Transmission Expansion Advisory Committee – FirstEnergy (ATSI) Supplemental Projects

April 11, 2023

Customer - North Star BlueScope Steel 345 kV Expansion

Need Number: ATSI-2019-082
Process Stage: [Re-Present Solutions Meeting – 04/11/2023](#)
Previously Presented: Need Meeting – 11/22/2019
Solutions Meeting – 11/04/2020

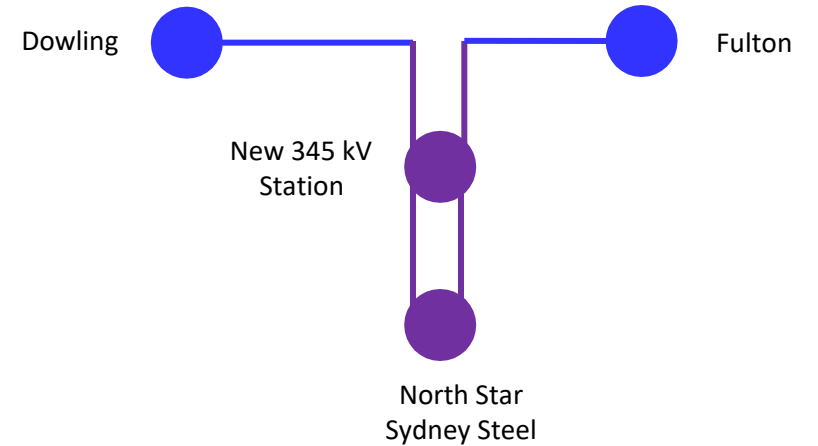
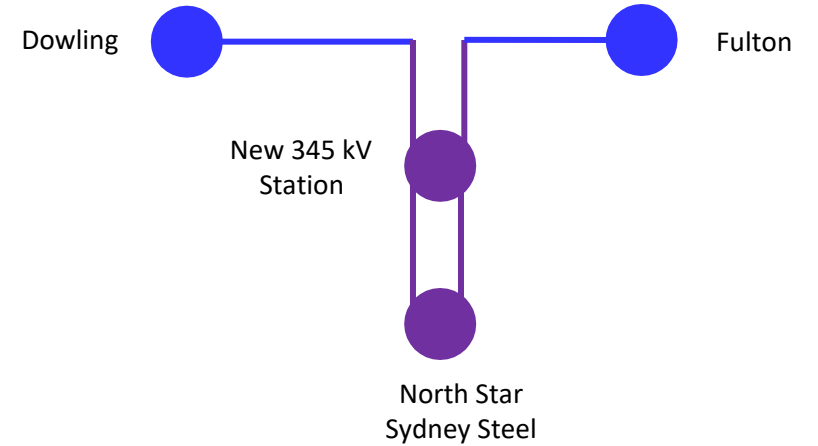
New additional scope to mitigate load loss criteria violation (§2237.2):

Contingency: P6 Loss of the Fulton-North Star Steel 345 kV Line and any additional line.

Ex. Loss of Fulton-North Star Steel 345 kV Line (300 MW) and loss of the Allen Junction-Westgate 138 kV line (79 MW) totaling over 379 MW of load loss.

- Construct a new 345 kV four breaker ring bus.
- De-energize approx. 1.0 mile of the Dowling-Fulton 345 kV line.
- Construct 8.7 miles of 345 kV line to connect the Dowling 345 kV line into the new 345 kV station with 954 ACSR 45/7 bundled (2 conductors per phase). ~~New 345 kV line to be built and share structures with the Delta-Wauseon 138 kV line and Delta-Fulton 138 kV line.~~ New greenfield 345 kV line to be built as preferred option based on the results of route selection study that was conducted. This route also avoids more densely populated areas near the town of Delta. The line will primarily be constructed on steel monopole structures.

- Replace the wave trap at Dowling 345 kV line to ensure the Dowling-New 345 kV station 345 kV transmission line is the limiting element.
- Re-terminate the Fulton 345 kV line that serves North Star Steel Sydney into the new 345 kV station.

- Provide two feeds from the new 345 kV station to North Star Steel Sydney with 954 ACSR 45/7 bundled (2 conductors per phase).
- Since conceptual estimate previously presented, material prices for the 345 kV line and the four breaker ring bus have escalated. In addition, a more extensive real estate review has been conducted and anticipate much higher ROW acquisition costs.

- Construct a new four breaker 345 kV ring bus. Construct a six breaker 138 kV ring bus and tie it to the 345 kV station with transformation. Re-terminate the Fulton-North Star Steel Sydney 345 kV line into the new 345 kV station. Expand Fulton substation to install a second 345/138 kV transformer. Expand Delta substation to install a second line from Fulton-Delta 138 kV. Rebuild the Delta Wauseon 138 kV line as double circuit and loop in the double circuit line into the new 138 kV Ring Bus. (~~\$107.2M~~-\$128.2M, Conceptual Estimate)

Estimated Project Cost: ~~\$67M~~ \$104.3M
Projected In-Service: ~~6/1/2024~~ 6/1/2026
Status: ~~Conceptual~~ Pre-Engineering
Model: 2020 Series 2025 Summer RTEP 50/50
